Product : Home Theater System	Bulletin No. : 03-Audio-0008
Model : HT-DB120	Bulletin Date : 2003-12-11
Buyer : All Buyers	ECN Date : 2003-12-11
SUBJECT : Countermeasure of Adding VCD playback funtion

DIODE METRIX Location NO(XD11 Delete)

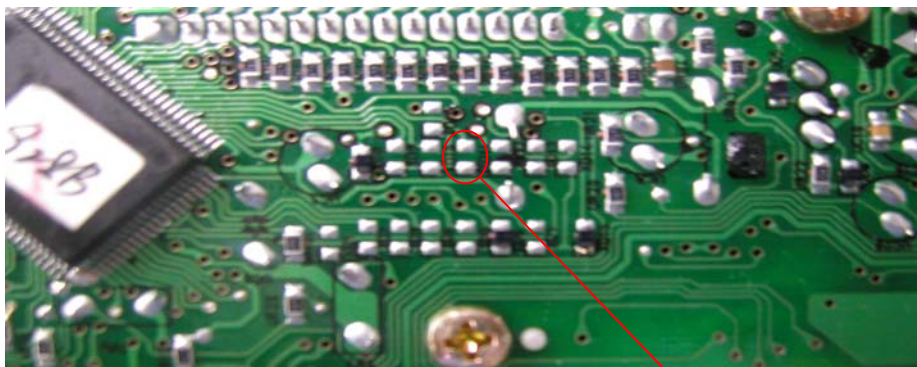
Background : When playing back an VIDEO CD DISC(VCD), do not play your VCD
(Symptom)

Solution : How to Playing back an VCD.
>Just delete Location No XD11(1SS355) of Front PCB in status of " POWER OFF"

- 1) Main u-com reset
 - > press the STOP button during 7 second in status of standby.
" standby RED LED in the twinkling "
- 2) MPEG reset.
 - > Press the STOP button during 7 second in status of " NO DISC"
" initial mode > Auto shut down"
